# UNITED STATES PATENT AND TRADEMARK OFFICE

APPLICATION NO.	FILING DATE	FIRST NAMED INVENTOR	ATTORNEY DOCKET NO.	CONFIRMATION NO.
09/988,322	11/19/2001	Hiromasa Ishiwata	356202/00	8420

**Office Action Summary**

## **DETAILED ACTION**

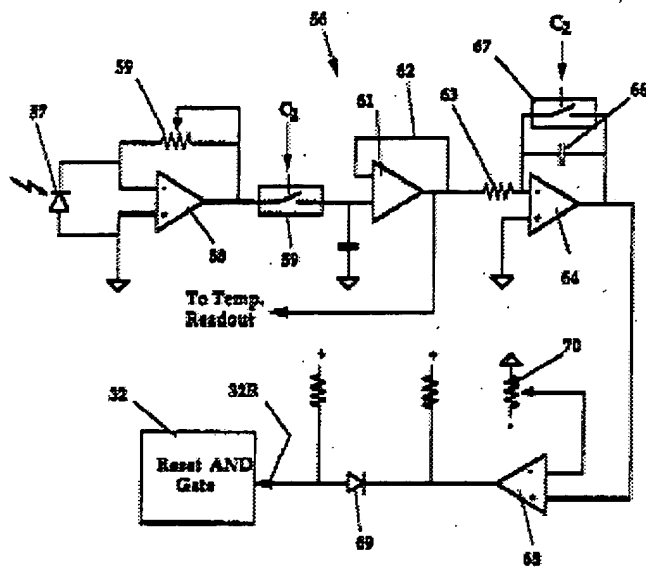
Regarding to claims 1,2,8 and 9, Rink disclosed in fig. 2 a control circuit for laser diode, comprising: an amplifier circuit (64) producing at an output terminal and feedback voltage that is indicative of an optical power via PD (57) generated by laser

diode (not shown) in response to a driving current flowing there through; a driving circuit responding to output voltage to control driving current so as to make voltage difference small; a second amplifier circuit (61) producing at a second output terminal. (See Fig. below). It is inherent that amplifier circuit driving output terminal with a first time constant during a steady operation (created by two switch C2 ) and with second time second time constant because, when switch(67) is off (open) the gain the operation amplifier (66) is determined by the resistor (63) and capacitor (66), the RC operating to suppress overshoot and/or undershoot of the signal, thus amplifier (64) drives the terminal with a first time constant. When switch (67) is on (close) and switch (59) open then the operation of amplifier (64) functions as a voltage follower in spite of the resistor (63) and capacitor (66). Thus, the amplifier 64 drives with a second time constant that is smaller the first time constant. (See Fig. below);

Regarding to claim 3, and 10 Rink discloses at least one of first and second amplifier circuit includes an operational amplifier (64 and 61), a capacitor (66) coupled between output and input ends of operation amplifier and first switch (67) coupled in parallel to capacitor (66) (See column 6, line 28 – 53 and Fig. below)

Figure\_2

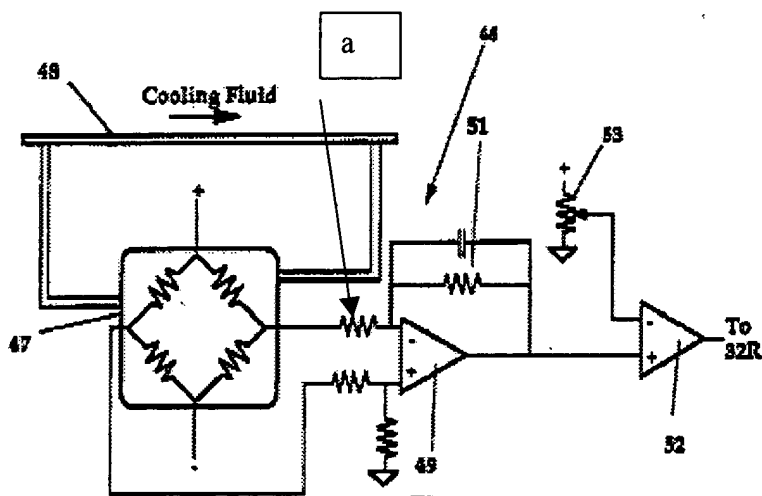
Regarding to claim 22, Rink discloses amplifier (49) circuit further a first resistor (a), a second resistor (51) coupled in parallel to capacitor (See fig. below).
